ADDENDUM TO THE CONTRACT

JUNEAU MEDICAL CENTER FIRE ALARM SYSTEM REPLACEMENT Contract No. BE20-212

ADDENDUM NO.: THREE

1 FLOOR PLAN - LOW VOLTAGE

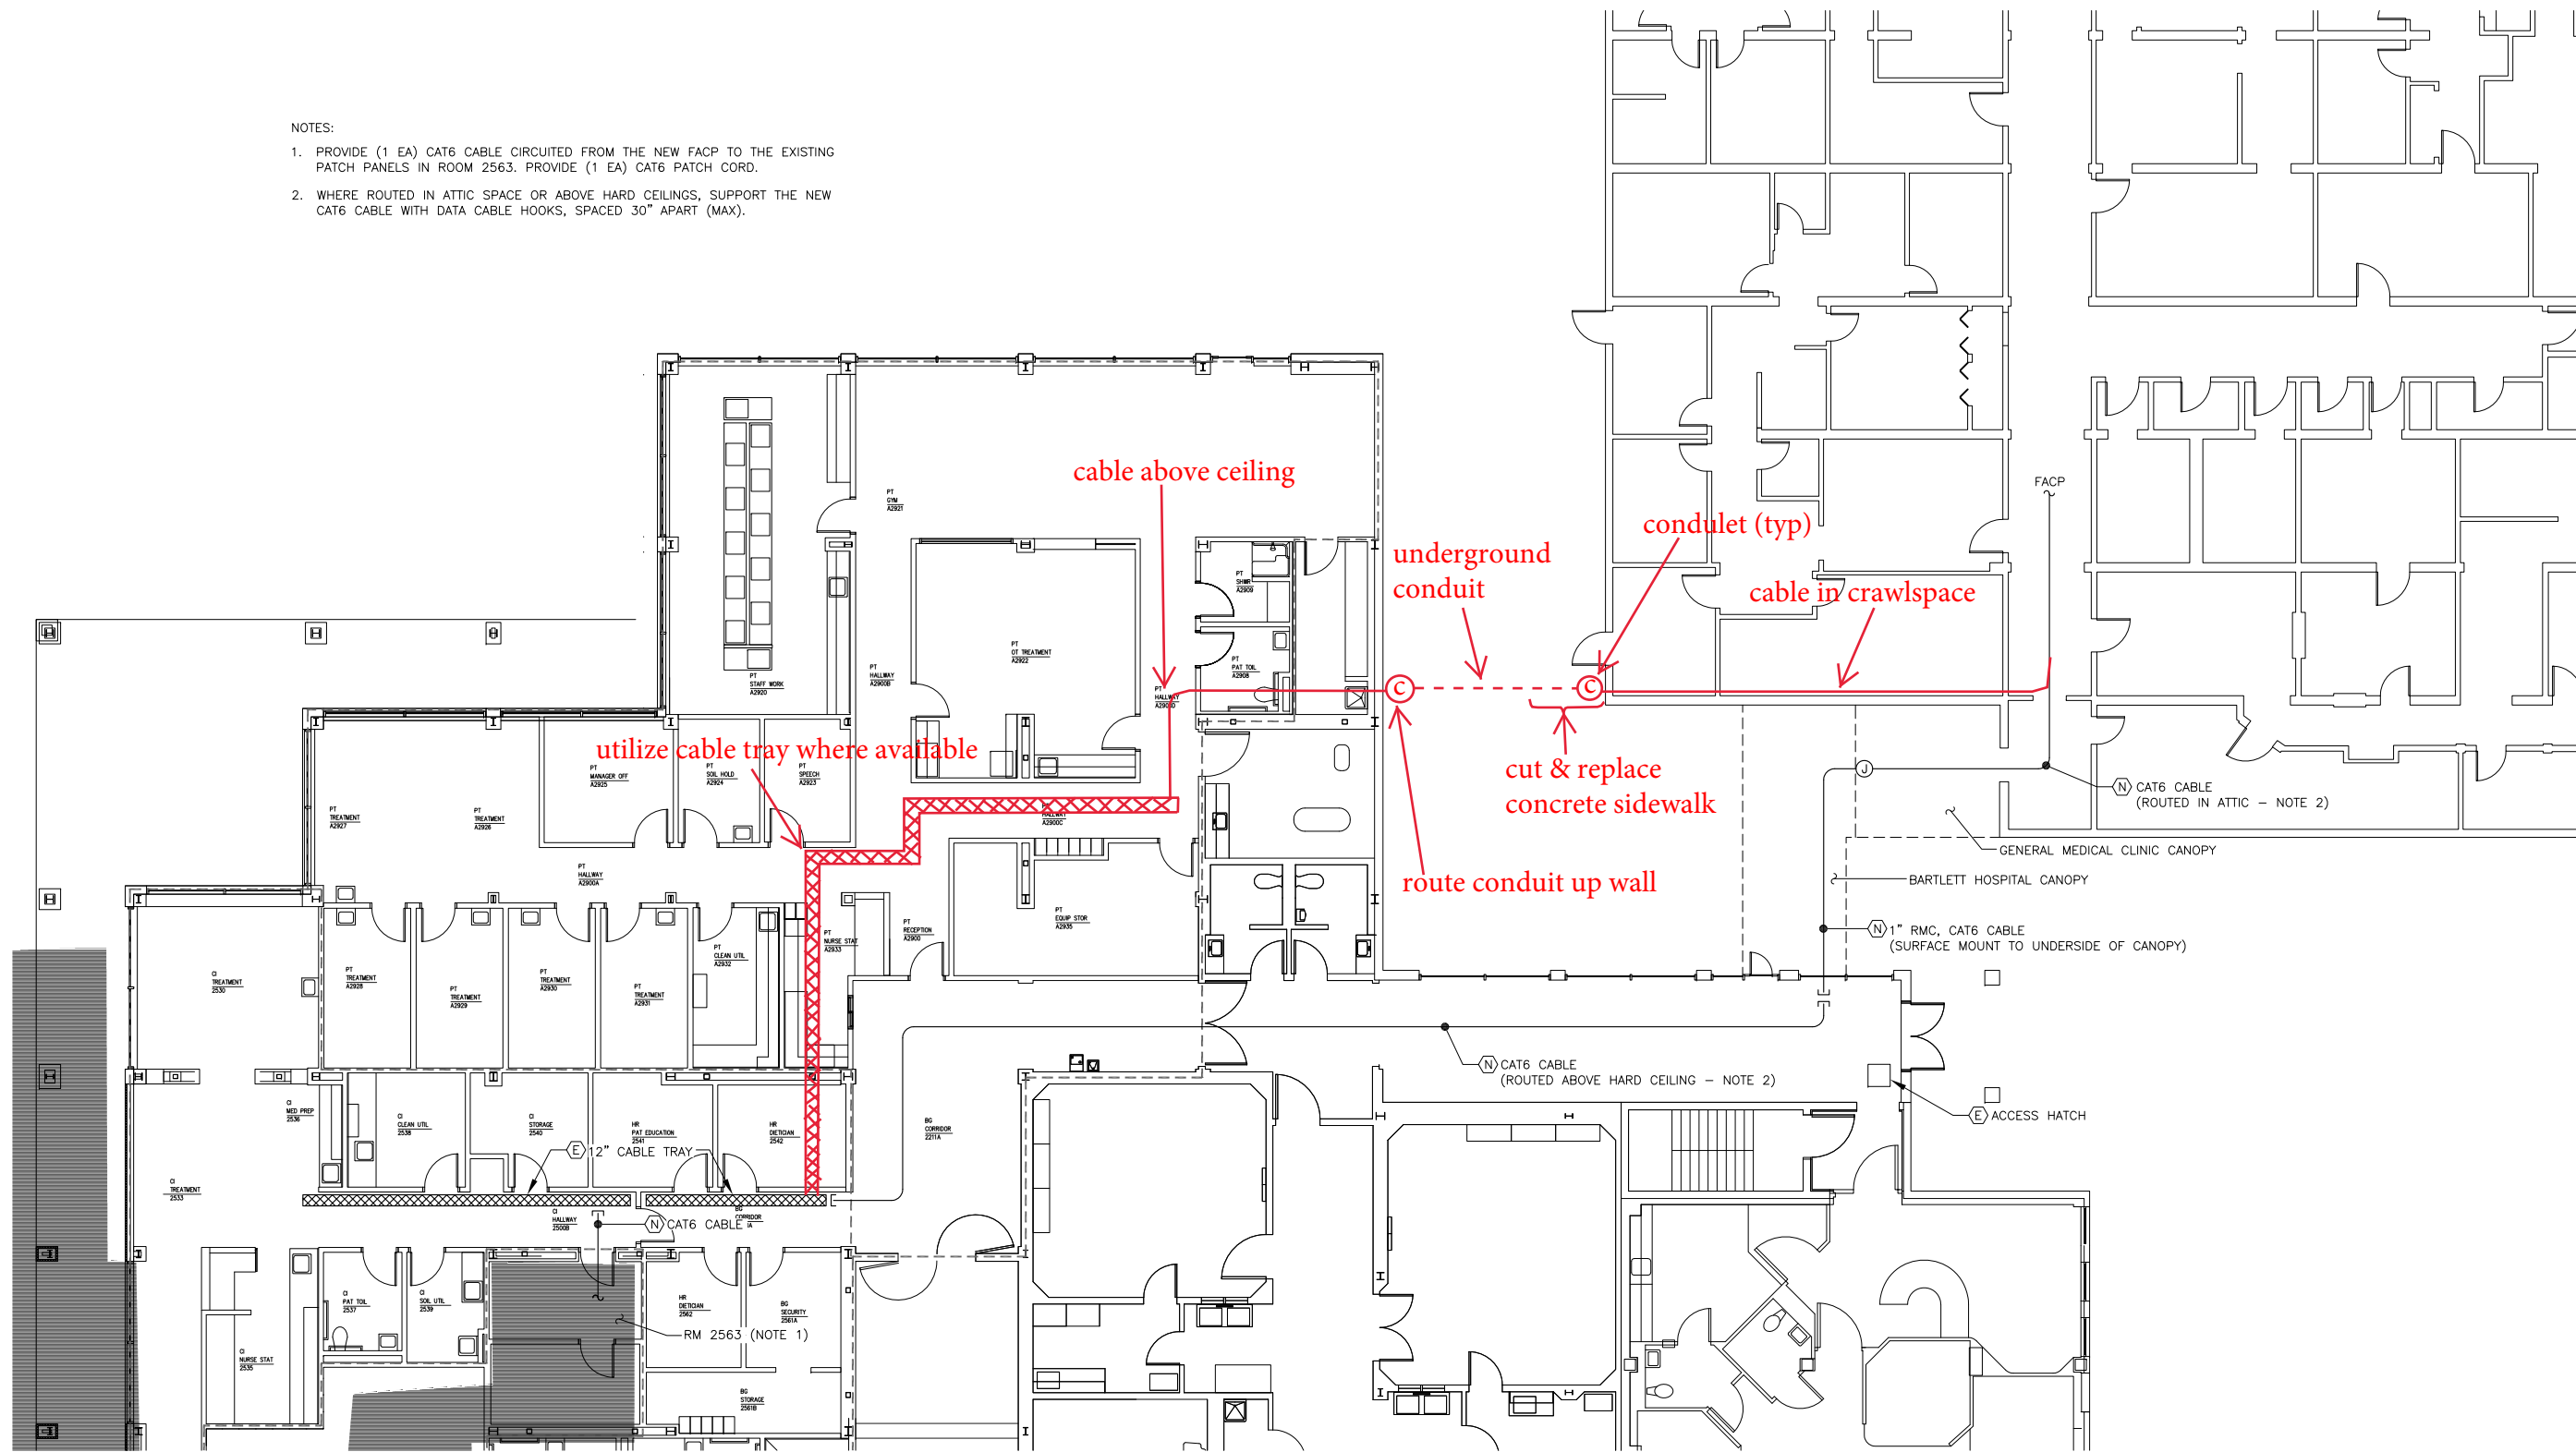
Response: All ceilings in the JMC are hard lid. All ceilings on the proposed route through BRH are suspended acoustic tile (drop ceilings) with the exception of the restroom. Attached is a drawing sheet illustrating an alternative route for the communication cable, which may provide an easier installation.

Response: The Soffit finish materials are the same as the exterior of the BRH building (photos on the FTP site). An alternative route is available (see attached drawing) which can bypass the soffit altogether.

1. PROVIDE (1 EA) CAT6 CABLE CIRCUITED FROM THE NEW FAC TO THE EXISTING PATCH PANELS IN ROOM 2563. PROVIDE (1 EA) CAT6 PATCH CORD.
2. WHERE ROUTED IN ATTIC SPACE OR ABOVE HARD CEILINGS, SUPPORT THE NEW CAT6 CABLE WITH DATA CABLE HOOKS, SPACED 30" APART (MAX).
